2. RIDEAU RIVER MULTI-USE PATHWAY CROSSING ENVIRONMENTAL ASSESSMENT STUDY RECOMMENDATIONS

Ref N°: ACS2011-ICS-PGM-0190

**SUBJECT: RIDEAU RIVER MULTI-USE PATHWAY CROSSING
ENVIRONMENTAL ASSESSMENT STUDY RECOMMENDATIONS**

RECOMMENDED PLAN

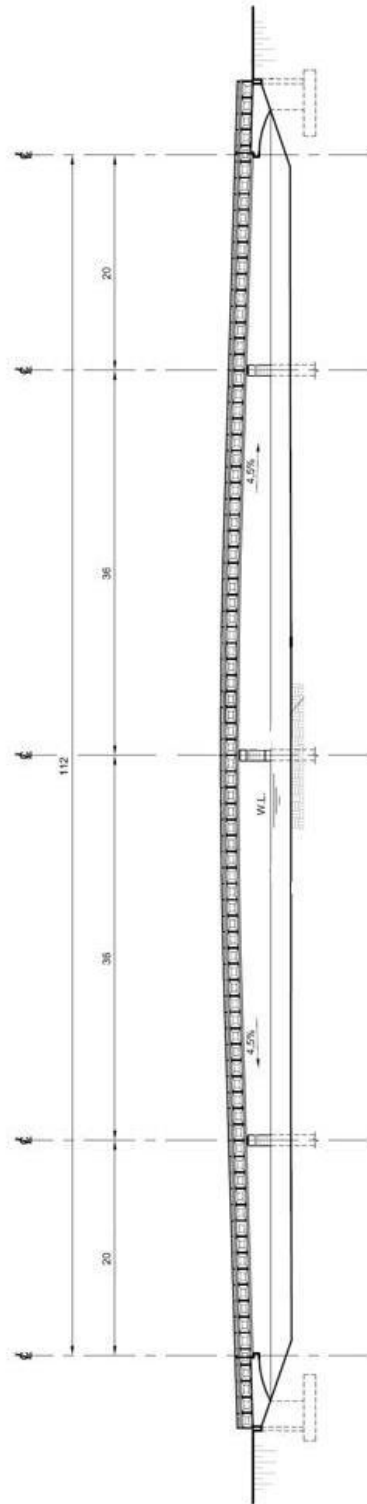
WHEREAS the RA Centre (Rideau Tennis Club) has expressed concern with the proposed reduction in the number of parking spaces on the north side of Donald Street due to the proposed re-orientation as Parallel parking;

AND WHEREAS it has been determined that this reduction in the number of parking spaces can be avoided by maintaining an angled or perpendicular parking arrangement while still being able to accommodate a new multi-use pathway and tree replacement on the south side of the roadway;

THEREFORE BE IT RESOLVED that the Recommended Plan for the Rideau River Multi-use Pathway Crossing Environmental Assessment Study be revised to provide for this change to the parking space design on the north side of Donald and multi-use pathway and tree replanting on the south side.
